Brookline Preservation Commission Local Historic District Report

Address: 89 Essex Street District: Cottage Farm LHD Applicant: Judith Paprin

Sketch of a roof plan noting the location of the proposed replacement

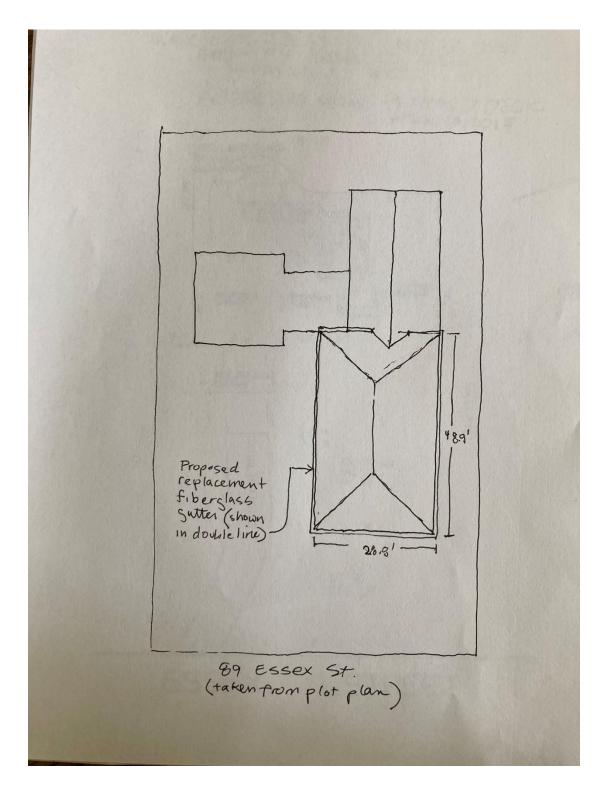
The applicant is proposing to replace the existing 6"x4" wood gutters on the roof of the main body of the house with fiberglass gutters that resemble as closely as possible the outside dimensions and profile of the existing wood gutters. The gutters are proposed to be painted to match existing conditions. The fascia board will be repaired/replaced in kind with wood as necessary. There is no proposed change to the existing copper downspouts.

Specification of proposed gutter and profile provided by Fibergutter

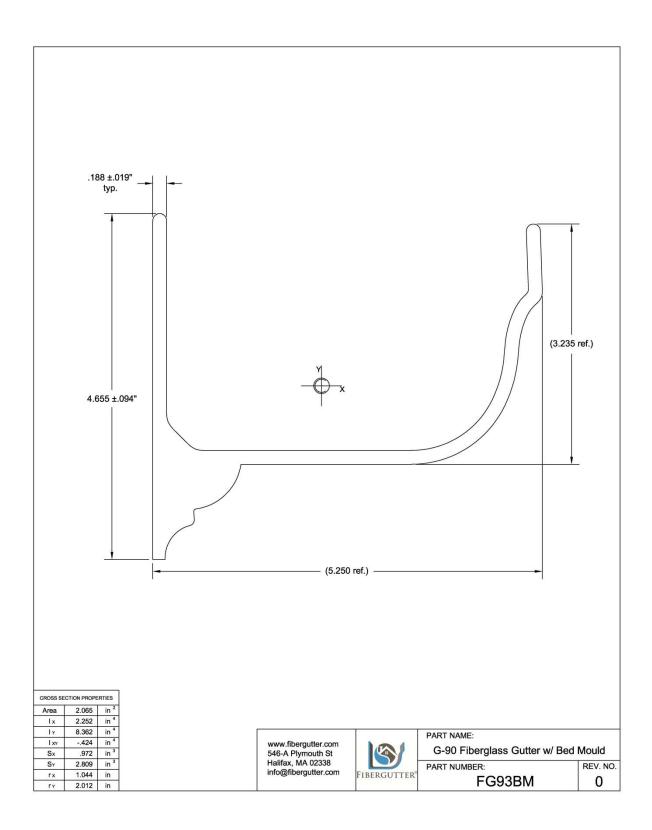
During the Commission's subcommittee meetings in regards to the Design Guidelines of Local Historic Districts, commissioners discussed and appeared interested in the possibility of allowing fiberglass or composite gutters in local historic districts, and have since approved fiberglass gutters in Pill Hill, Chestnut Hill North and Graffam McKay Local Historic Districts. This application appears consistent with those approvals as the applicant is proposing a material change to the deteriorating gutters only, with no change to the fascia or downspouts, and is proposing to match in dimension and profile, the existing wood gutters as closely as possible.
